**Supplemental Proposals to Revising the
Northern California Metroplex
For Alameda County/Contra Costa County**

**Oakland Airport-Community Noise Management Forum
January 2017**

Figure 5: Published HUSSH TWO departure off OAK.

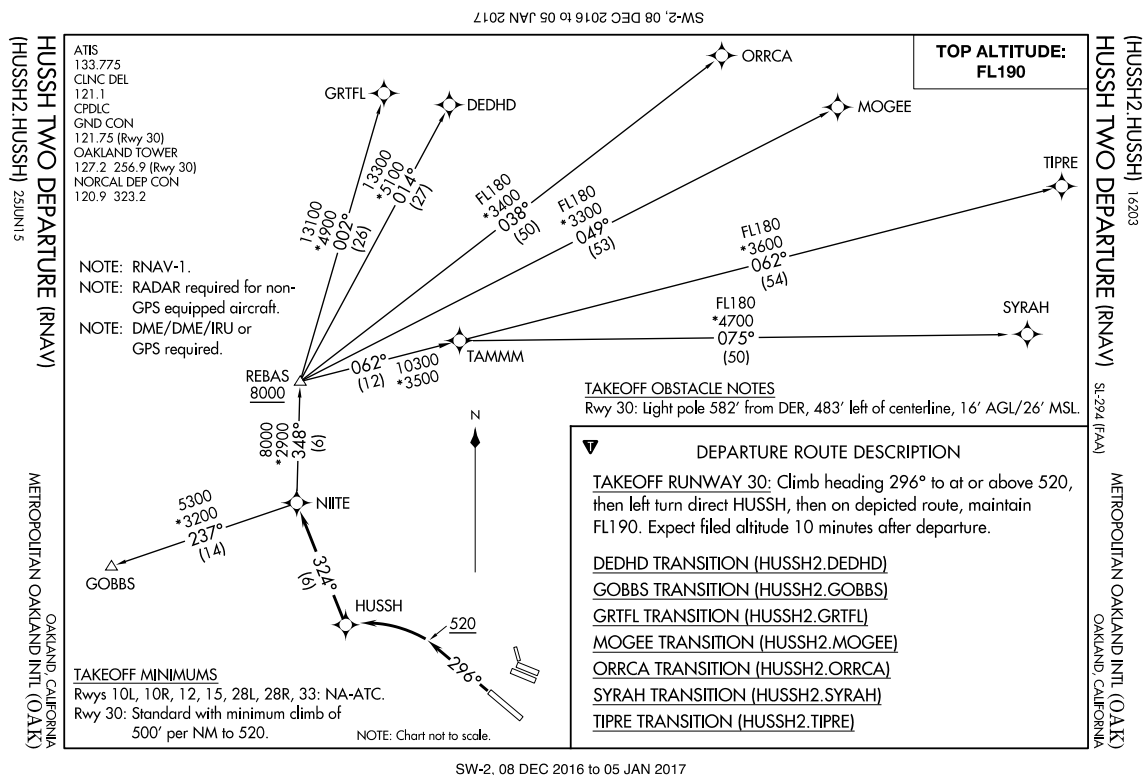
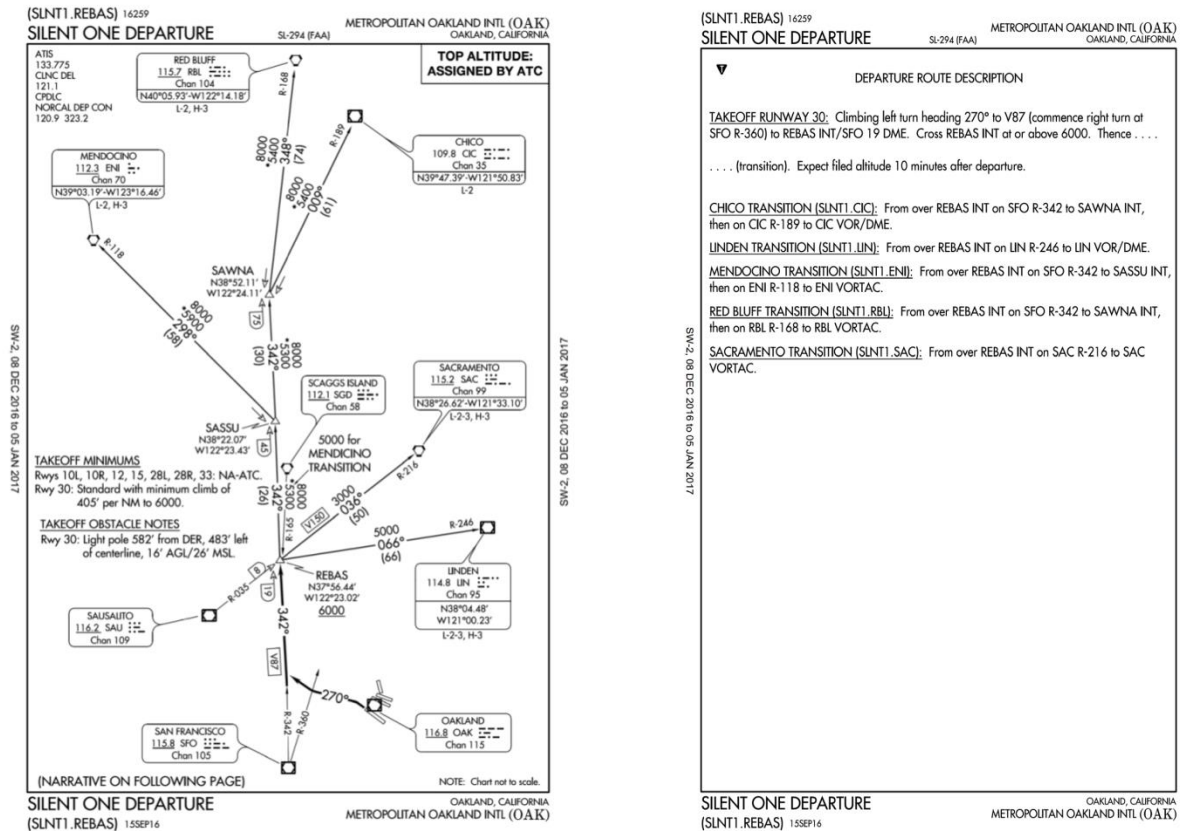
After analyzing flight tracks of aircraft on the HUSSH departure procedure as compared to the SILENT SID procedure (Figure 6), the Noise Forum has concluded that the HUSSH procedure is less effective at keeping aircraft away from BFI/Alameda as the initial turn over the San Francisco Bay occurs later and the turn itself is not as sharp. Because of this, aircraft departing OAK Runway 30 fly much closer to BFI/Alameda than they did previously under the SILENT. In the early morning and late night hours, aircraft noise is especially disruptive given the low ambient noise levels. Although the total number of nighttime flights may not seem high, the impact of these flights close to the shoreline throughout the night is very impactful to the residents.

Analysis of aircraft flying HUSSH also demonstrates the overwhelming majority of flights are currently allowed early turns eastward over Oakland and Berkeley instead of flying the route as charted to REBAS. This places aircraft at least 1000 to 5000 feet lower in altitude during nighttime hours over densely populated areas in Oakland, Berkeley, and other areas. In the early morning and late night hours, aircraft noise is especially disruptive given the low ambient noise levels, which have been measured to drop as low as 29 dBA in the Montclair residential area of Oakland.

SILENT was designed for noise abatement and kept aircraft over the water during the lower portion of the aircraft climb profile to REBAS intersection. The NextGen HUSSH procedure eliminated the charted heavy line to REBAS that was published under SILENT. This elimination allowed greater discretion for early turns prior to aircraft reaching the REBAS waypoint and greatly undermining

The current routing of the HUSSH TWO brings aircraft ground tracks closer to BFI, Harbor Bay, and Alameda resulting in increased noise. The short-term solution would be for Air Traffic Control to assign headings to aircraft departing OAK runway 30 that restore the initial SILENT ground track. Other issues with the HUSSH TWO departure and proposed solutions are detailed in this document and are addressed separately. Additionally, the FAA should ensure aircraft remain on their filed route and not turn prior to REBAS intersection.

The Noise Forum is requesting FAA evaluate the HUSSH procedure and adjust it to replicate the SILENT SID ground track and require aircraft to fly to REBAS unless safety dictates otherwise.

1. moving HUSSH waypoint southward as much as feasible to facilitate a sharper left turn by aircraft after departing OAK Runway 30; and
2. regulate and eliminate early turns off of HUSSH by issuing an FAA Air Traffic Control directive that aircraft fly the full HUSSH departure all the way to REBAS intersection for published noise abatement purposes unless safety dictates otherwise; and
3. modifying the location of REBAS closer to the Bay to better mitigate noise at Point Richmond; and

Figure 7: Published WNDSR TWO arrival into OAK.

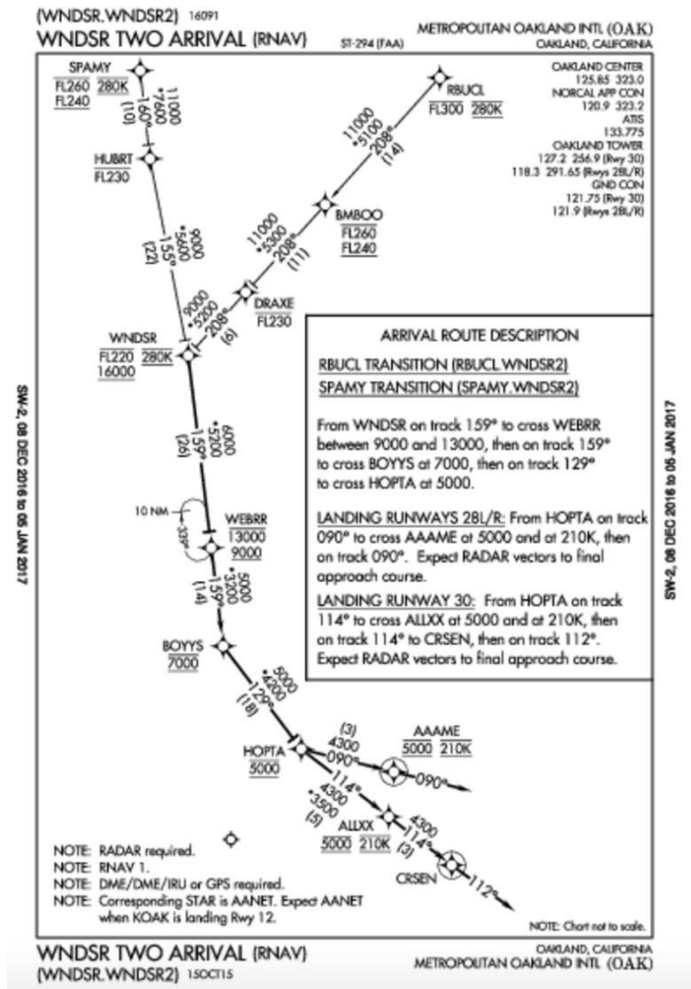
OAK arrivals from the north were previously vectored over a seven-mile-wide corridor prior to NextGen. Creation of the WNDSR RNAV to handle this previously dispersed traffic shifted and concentrated all traffic to a corridor less than 0.5 miles wide over the topographically highest area of the East Bay Hills. This significantly impacted densely populated residential areas including Berkeley, Oakland, San Leandro and others. Daytime ambient monitored noise levels are less than 50dB and typically less than 45dB in much of these areas. Single aircraft noise levels over 78dB have been measured.

WNDSR TWO is designed for arriving traffic from the north and north east including polar traffic. This traffic must fly a considerable distance westward to pick up the WNDSR arrival and then subsequently fly eastward again to merge into the OAK arrival procedure. WNDSR lengthens flight paths and reduces efficiency.

The WNDSR TWO procedure requires level or nearly level flight under thrust for over 23 nautical miles at altitudes commonly down to 4000 feet MSL along the East Bay Hills which rise up to 1700 feet MSL. This causes excessive fuel burn and particulate emissions. Further, as the ridgeline under WNDSR TWO rises up to 1700 feet MSL, it also results in dramatically concentrated noise impacts. Moving WNDSR TWO would free airspace for departing OAK and SFO traffic and increases safety by reducing potential conflict with OAK arrivals. Moving WNDSR has additional benefits by allowing SFO departures to adopt fuel efficient and noise mitigating ascent profiles in the future that would not be possible with the restrictions that WNDSR imposes.

The Forum requests that the current WNDSR TWO flight track be eliminated and the FAA consider options to replace this RNAV to another location that allows for geographically shorter flight paths and quiet, fuel efficient optimized descents into OAK. Moving WNDSR TWO has an additional significant advantage in that it frees airspace so that SFO and OAK departures can eventually use quieter and more fuel efficient continuous climbing procedures.

Figure 12: Published OAKLAND NINE departure from OAK.

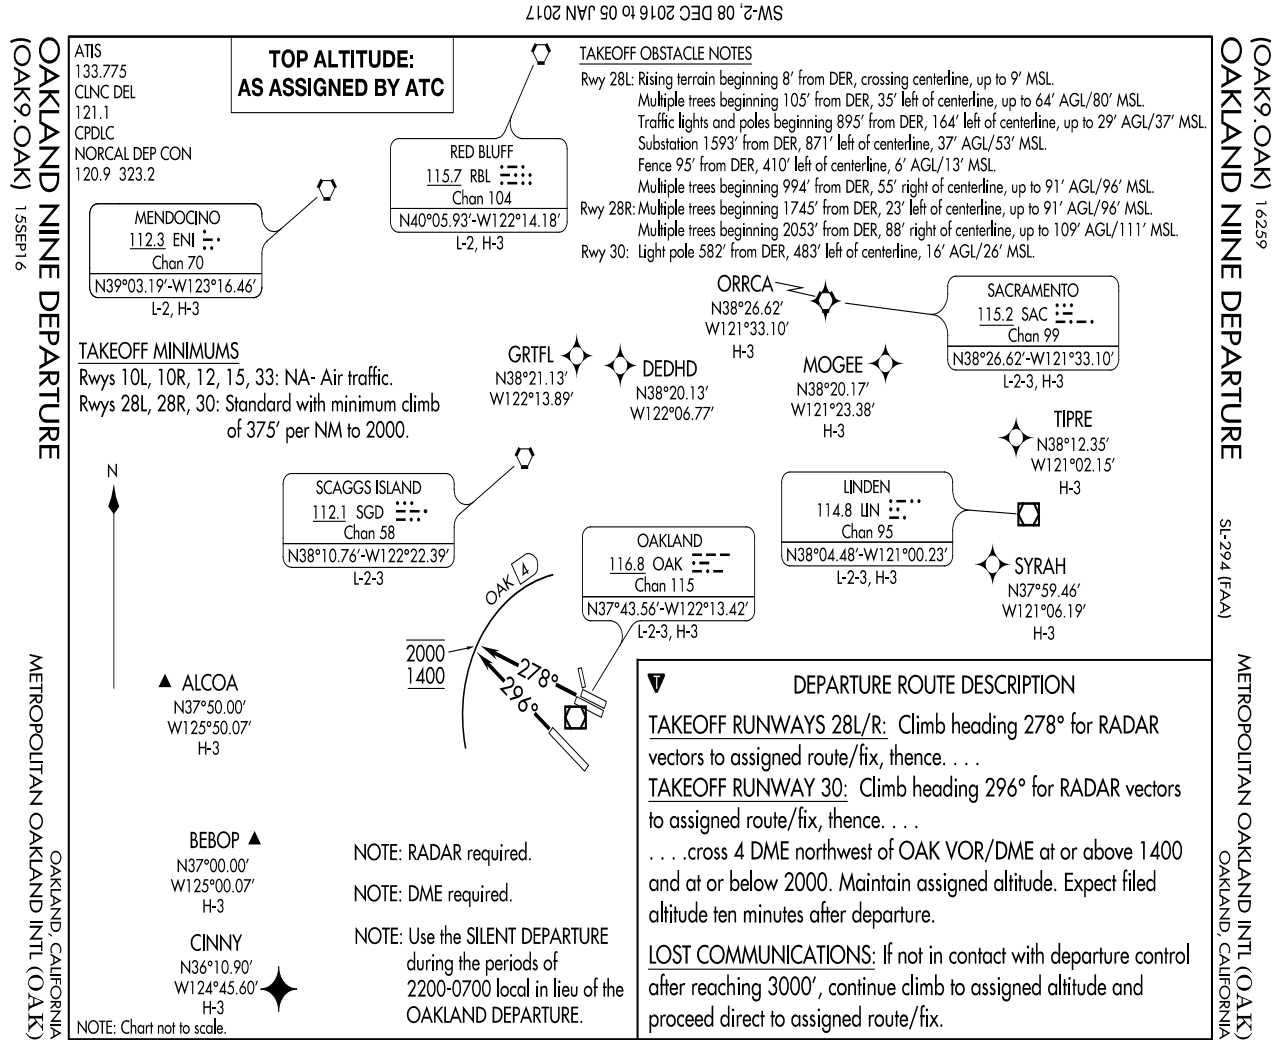
The imprecise nature of the OAKLAND NINE departure creates excessive noise for BFI, Alameda, and East Bay communities. Aircraft departing the Oakland Airport that are flying headings and receiving vectors do not fly a specific and consistent ground track that reduces noise. The implementation of NextGen technology and procedures as they apply to this departure can be leveraged to provide a solution and bring noise relief to East Bay communities.

The Forum requests that, in the short term, the FAA assign headings to aircraft after takeoff that direct aircraft turn left to a heading of 280° until reaching the OAK 4 DME arc, then proceed on the published departure.

The Forum requests that aircraft departing on the OAKLAND NINE not be turned eastbound until leaving 5000 feet (as opposed to 3000 feet in the current ATC directed noise mitigation procedures).

The Forum requests that the FAA evaluate the OAKLAND NINE (daytime departures) and adjust it so that the ground track is further away from BFI/Alameda. This could be accomplished by directing aircraft departing OAK Runway 30 to turn left to a heading of 280° until reaching the OAK 4 DME, then proceed on the published departure. The proposed adjustment would alleviate noise from aircraft flying too close to the BFI/Alameda shoreline. We also request the FAA consider creating an

Figure 13: Published CNDEL THREE departure out of OAK.

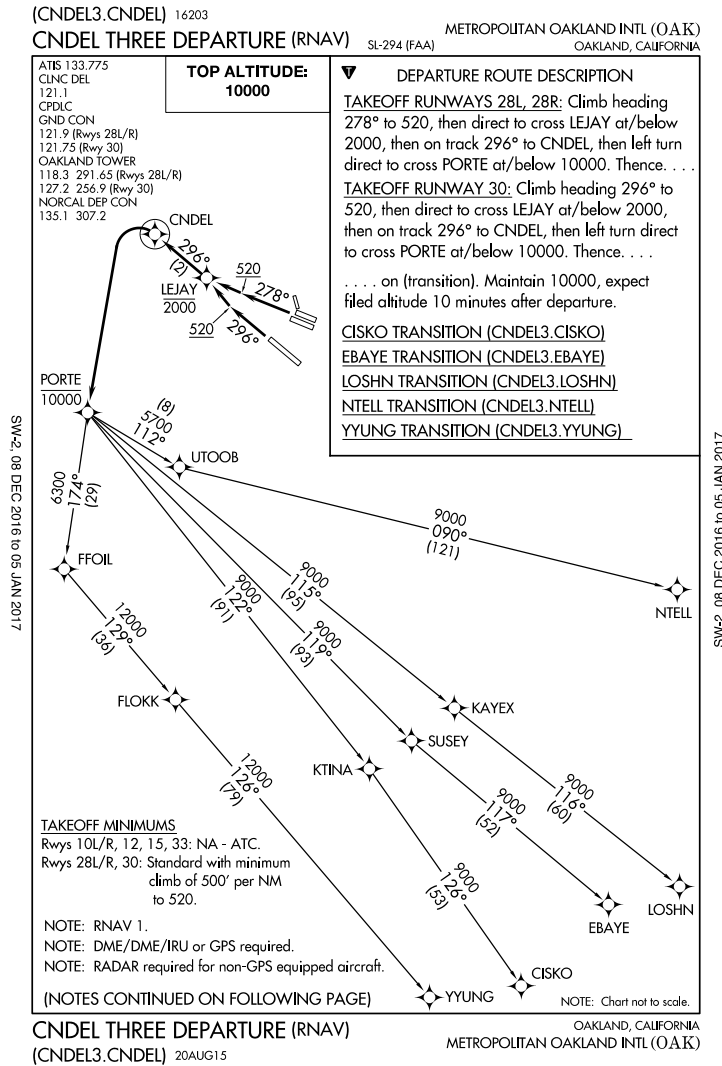
Aircraft ground tracks for this departure come significantly close to BFI and Alameda shorelines. A change to this departure as part of any Metroplex revisions would greatly reduce the noise impact of these flights.

Consider adjusting CNDEL THREE departure so that the ground track for this departure is further away from BFI/Alameda. This could be accomplished by directing aircraft departing OAK runway 30 to turn left to a heading of 280° until reaching the OAK 4 DME arc. This OAK 4 DME arc could replace the LEJAY intersection. This requested change would direct aircraft away from the BFI/Alameda shoreline sooner, which would reduce noise to residents.

Figure 14: Published NIITE THREE departure out of SFO.

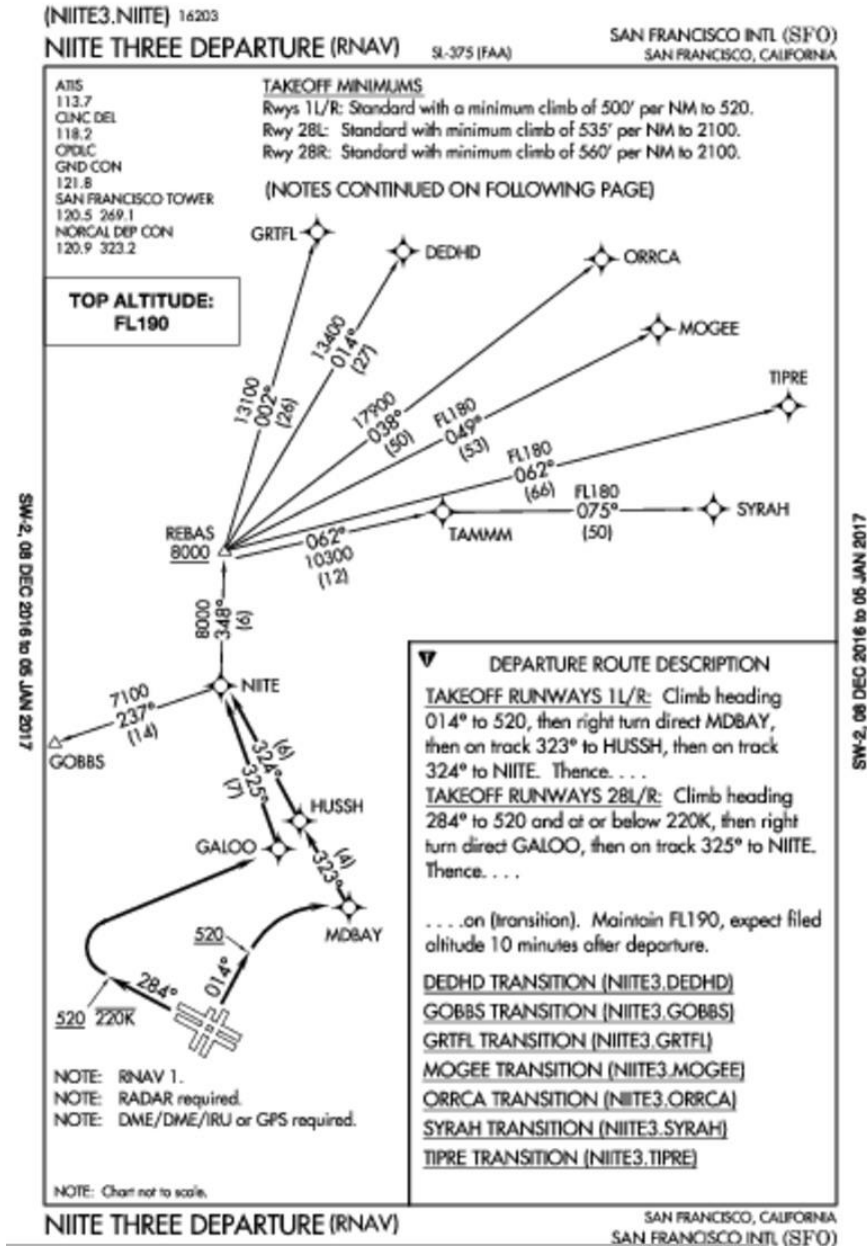
This procedure was intended to overlay, and replace, the prior QUIET DP (Figure 15). It was designed for noise abatement purposes and was charted to have aircraft fly to the REBAS waypoint at Point Richmond to keep aircraft over the water as much as possible during the lower portion of the aircraft climb profile. The QUIET procedure, provided significant nighttime benefit to the hillside residential areas of Oakland, Berkeley and northward was achieved by requiring that climbing aircraft under full thrust remain over the Bay and not turn eastward until at higher altitudes at REBAS intersection by Point Richmond.

The NIITE procedure was developed to provide a similar nighttime benefit by overlaying the legacy QUIET procedure. SFO departing aircraft track to HUSSH and from there, track 324° to NIITE thence are charted to track to REBAS at Point Richmond and cross at 8000 feet. This route has aircraft following a path that allows them to remain clear of both the west and east shorelines of San Francisco Bay until reaching a higher altitude, when a turn over land is less disruptive to residents at the REBAS waypoint at Point Richmond.

The Forum requests that the FAA restore the requirements of the nighttime noise abatement flight procedure as charted under SFO QUIET to SFO NIITE. Restore the heavy charted lines from NIITE to REBAS to indicate this is the charted route to fly unless safety dictates otherwise.

1. regulating and eliminating early turns off of NIITE by issuing an FAA Air Traffic Control directive that aircraft fly the full NIITE departure all the way to REBAS intersection for published noise abatement purposes unless safety dictates otherwise; and
2. modifying the location of REBAS to better mitigate noise at Point Richmond; and
3. adjusting night time hours for noise abatement operations from the current 2200 0700 local time Monday through Saturday, 2200 to 0800 local time on Sunday morning to new night time hours of noise abatement procedures of 2100 – 0900 local time daily, seven days a week for relief as flight curfews are not an option.

Figure 16: Published TRUKN TWO departure out of SFO.

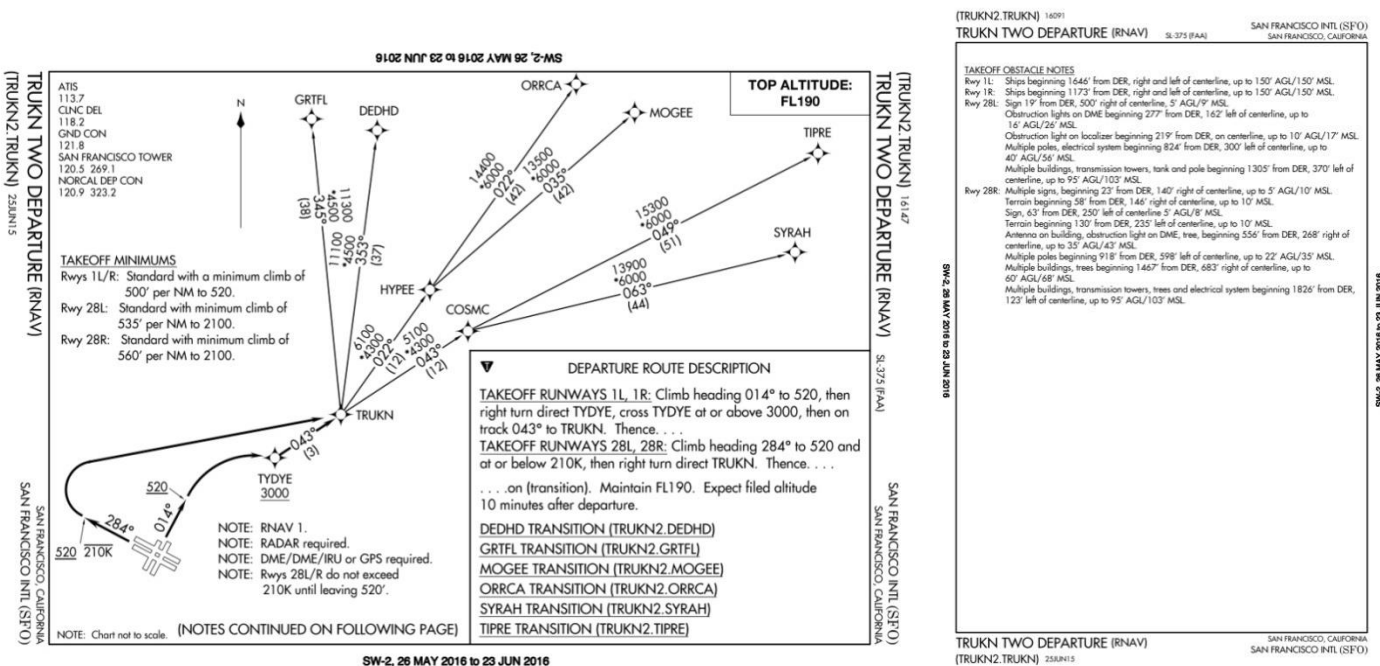
The publication of GRTFL and DEDHD shifted traffic eastward from its historical pattern and concentrated it on two new RNAV tracks over the topographically higher areas of Berkeley and Oakland. These areas now experience dramatic increased aircraft noise resulting from concentrated traffic on these new RNAV tracks where it did not exist prior to NextGen.

Examination of TRUKN East shows that prior to NextGen, SFO departing traffic was concentrated in two distinct corridors roughly corresponding to the NextGen HYPEE and COSMC RNAV tracks. However, there was a significant shift southeastward and concentration of traffic along HYPEE when it was published. This shifting concentrated traffic one mile south, and significantly increased noise for residential areas there.

The Forum requests the FAA consider TRUKN proposals in two sections as detailed above – TRUKN North and TRUKN East. The Forum also requests the FAA consider the WNDSR proposals above as part of overall noise mitigation for TRUKN. As detailed above, moving WNDSR TWO has additional significant advantage in that it frees airspace so that SFO and OAK departures can eventually use quieter and more fuel efficient continuous climb procedures.
